Bardstown Road/Baxter Avenue Corridor Review Overlay District

Report of the Urban Design Administrator To the Overlay Committee

Case No: 15BROD1023
Classification: Non-Expedited

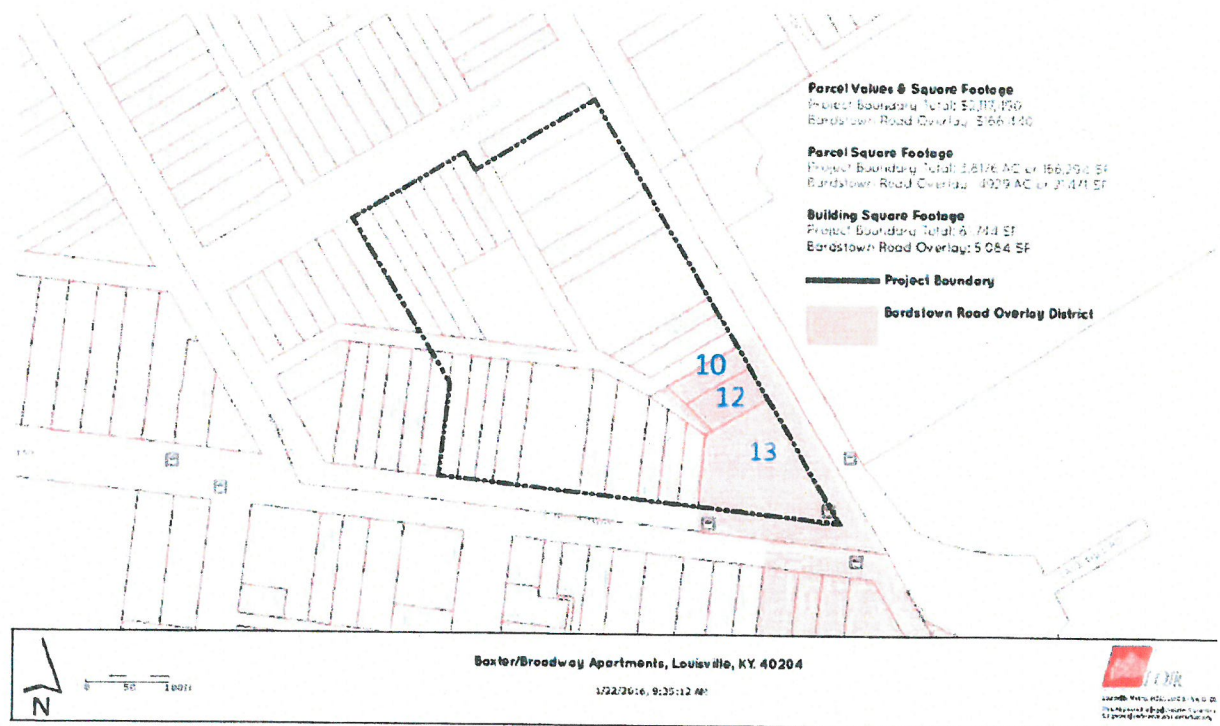
These three parcels are shown as #10 (652 Baxter Avenue), #12 (656 Baxter Avenue), and #13 (1249 E Broadway) on the submission map above. Parcel #10 is currently a vacant lot, and the structure on Parcel #12 will be razed for the development. Parcel #13 is currently surface parking. Approximately 15% to 20% (roughly 40,000sf) of the completed improvements will be constructed on these parcels, totaling an estimated \$6 million to \$8 million of the total budget.
